SEQUOYAH NUCLEAR PLANT UNITS 1 AND 2 DELAY OF REACTOR TRIP DUE TO ARCING ACROSS UNDERFREQUENCY RELAY CONTACTS

NCR EEB 79-13
10 CFR 50.55(e)
FINAL REPORT

SEQUOYAH NUCLEAR PLANT
 UNDERFREQUENCY INPUTS TO THE
 SOLID STATE PROTECTION SYSTEM
 (MODIFICATIONS DUE TO NCR EEB 79-13)

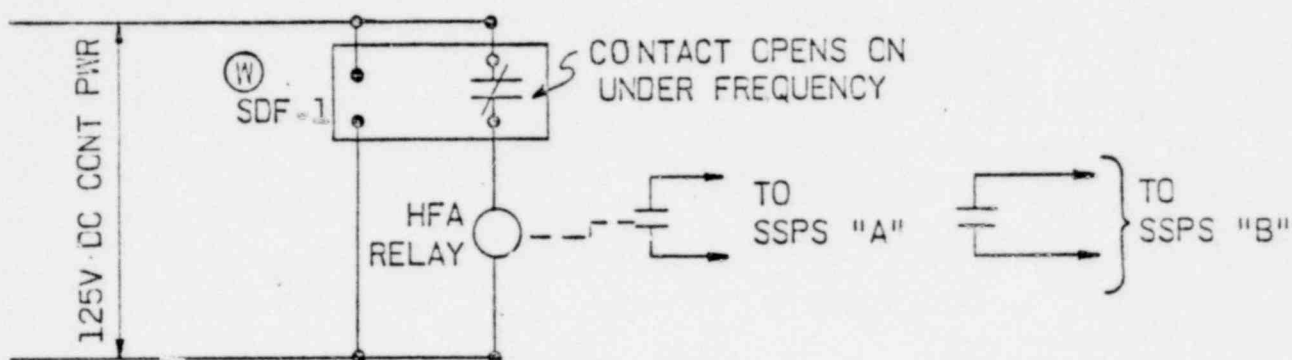
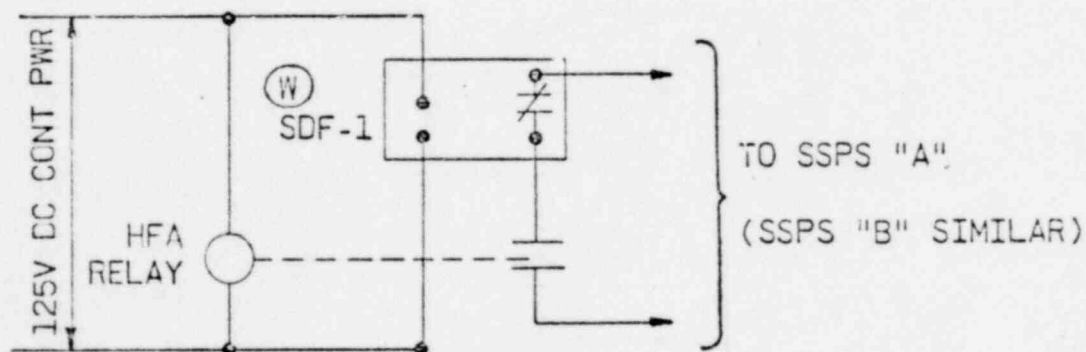
During the preoperational testing of the underfrequency inputs into the solid-state protection system, arcing occurred across the underfrequency relay contacts. The problem involves the underfrequency and auxiliary relays on the reactor coolant pump underfrequency and undervoltage protection panels. This arcing caused the auxiliary relay to chatter and delay the reactor trip and the reactor coolant pump breaker trip signals. There are two auxiliary relays associated with each reactor coolant pump.

The SDF-1 relay (see attached figure) senses the frequency by a solid state circuit which energizes a telephone type relay on underfrequency. Arcing occurs when the telephone relay contacts deenergize a large inductive load. The solid state circuits are adversely affected by noise generated by the arcing. This then causes the telephone relay to chatter which delays the trip signal to the SSPS.

The relay panel will have the SDF-1 relays modified internally so that there will be two normally closed contacts available for external connections (presently there is available only one normally closed and one normally open contact for external connections). The two normally closed contacts will be used to deenergize a small 120-volt ac general purpose relay located in the SSPS cabinets. Testing has verified that the VF relay will be able to energize and deenergize the small general purpose relay in the SSPS without contact chatter. The auxiliary relay will be used to monitor control voltage and will send a trip signal to the SSPS by opening contacts in series with the VF relay contacts upon loss of control power.

These modifications will be completed on Sequoyah unit 1 before fuel loading. Design changes have also been initiated for Sequoyah unit 2 and for Watts Bar Nuclear Plant units 1 and 2.
